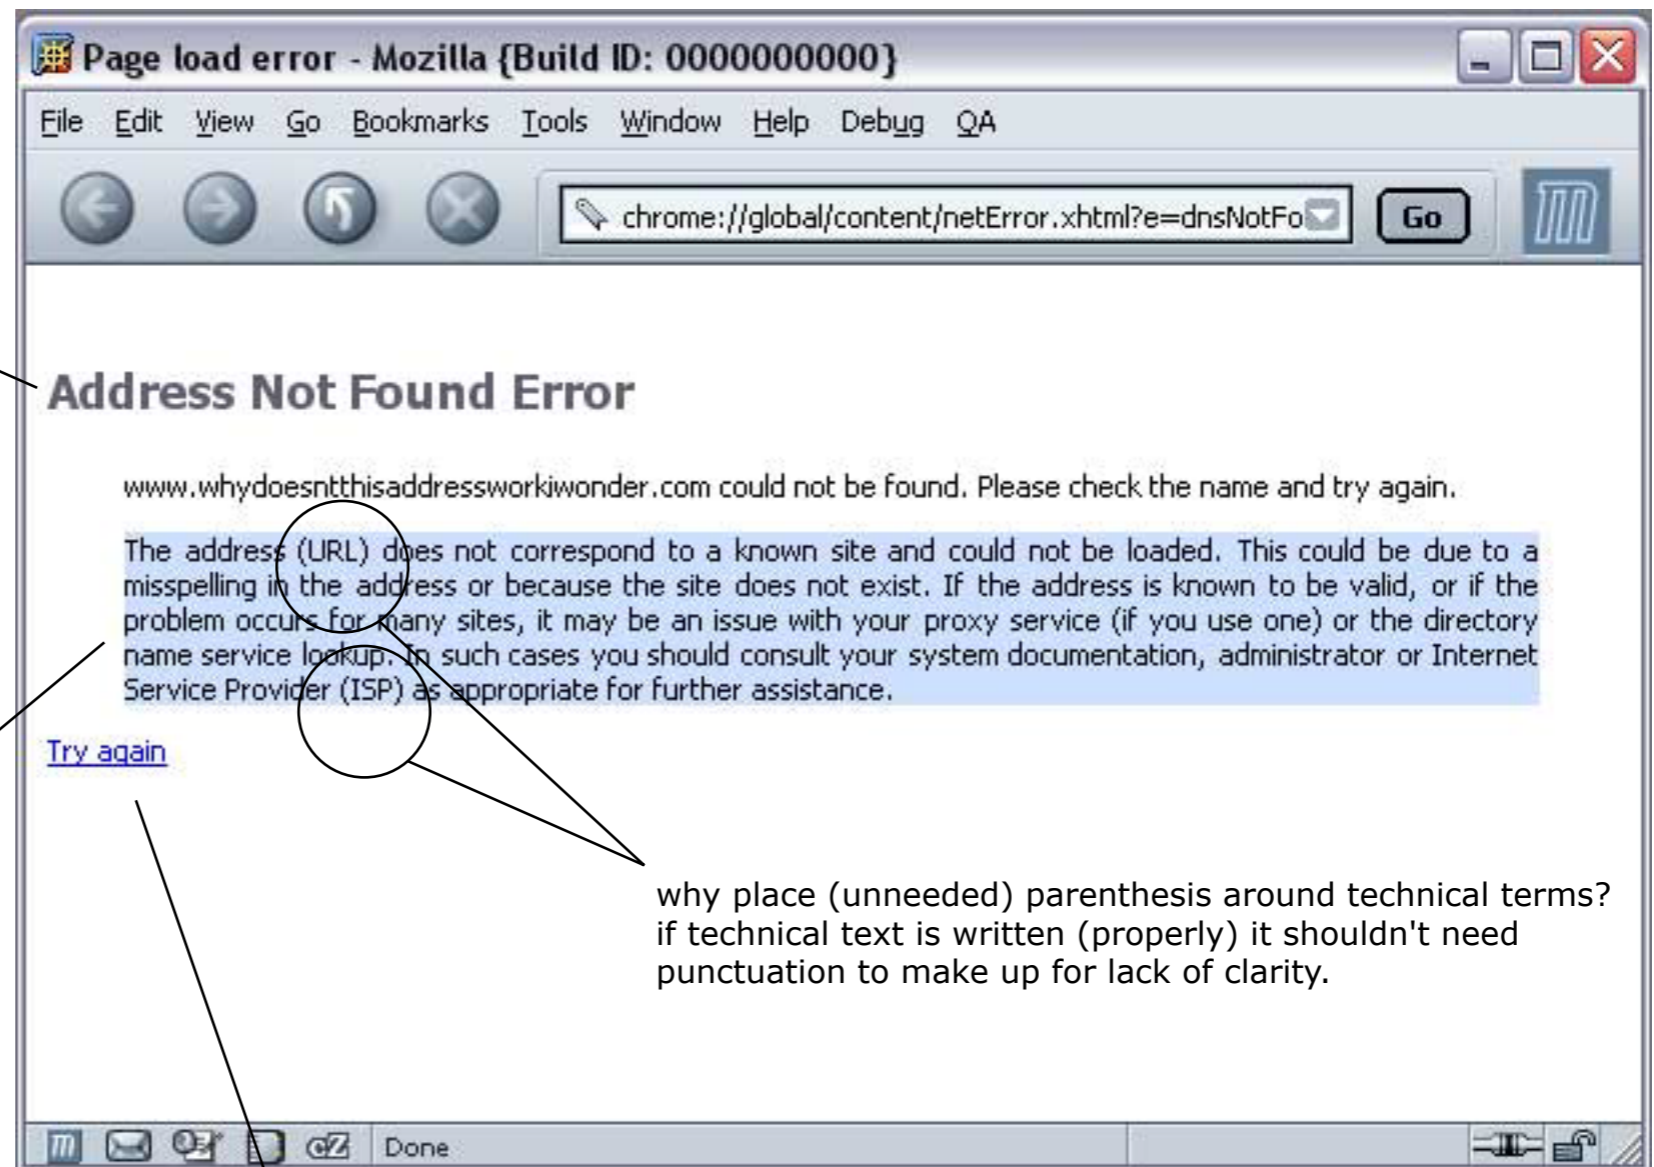
it is not clear, at a glance, what address was not found

too much contrast in type size between the heading and body copy

this blue is too dark in value decreasing the contrast between the type and background makes the text hard to read

why place (unnecessary) parenthesis around technical terms? if technical text is written (properly) it shouldn't need punctuation to make up for lack of clarity.

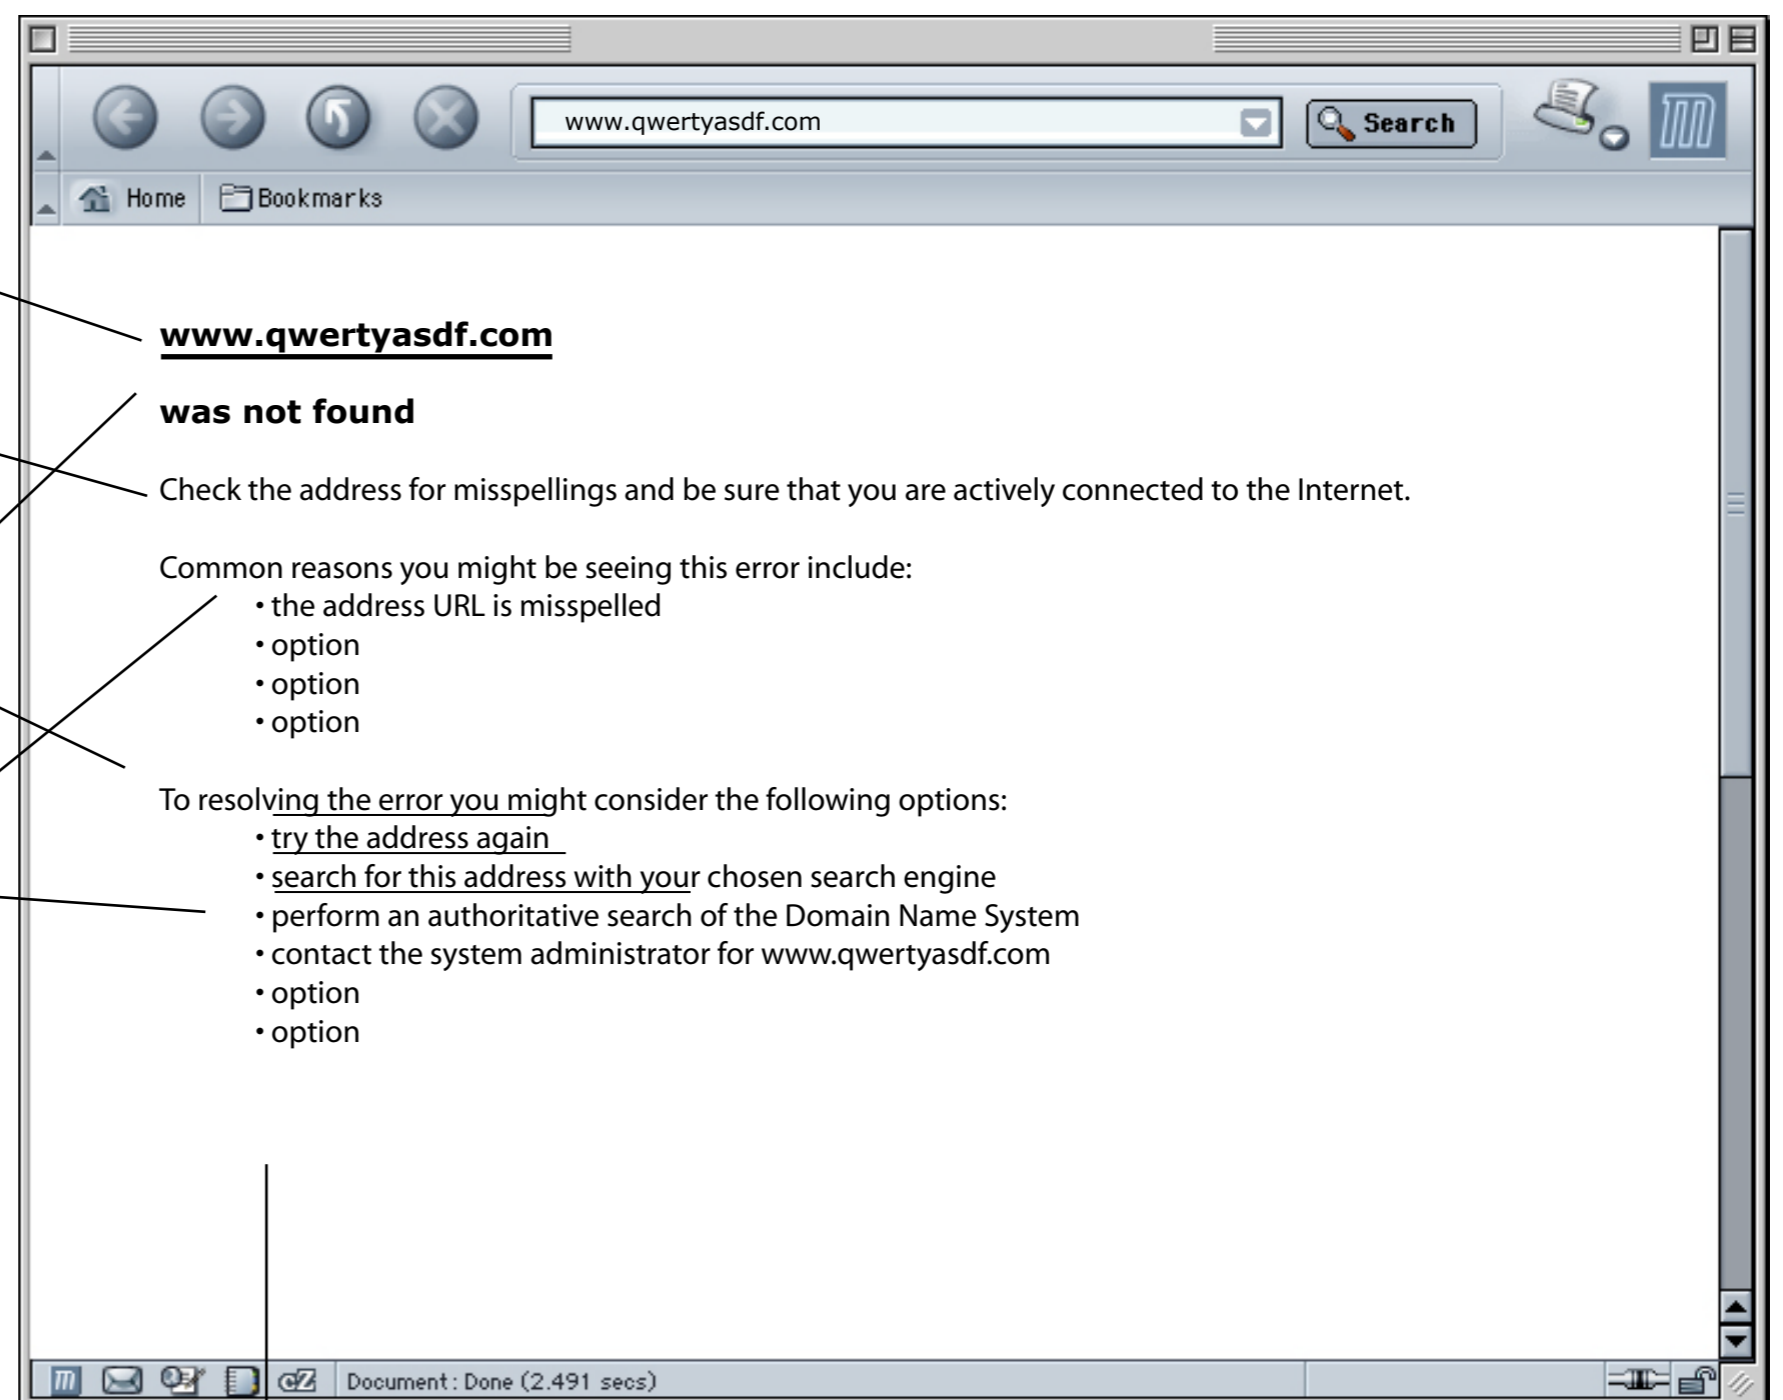
the position of this text is awkward, why separate this detail from the rest of the options or error text? it doesn't seem to have a rationale for its location, or clearly represent the available options

the address is on 1 line and is linked so you can 'try again' by just clicking

bare-bones error text

a single type size in 2 weights (bold and regular) provides sufficient contrast to clearly emphasize the details

very straightforward listings of common causes and solutions

the text is written in plain english, with technical terminology integrated into the text. the format is simple and straightforward with highly scannable copy
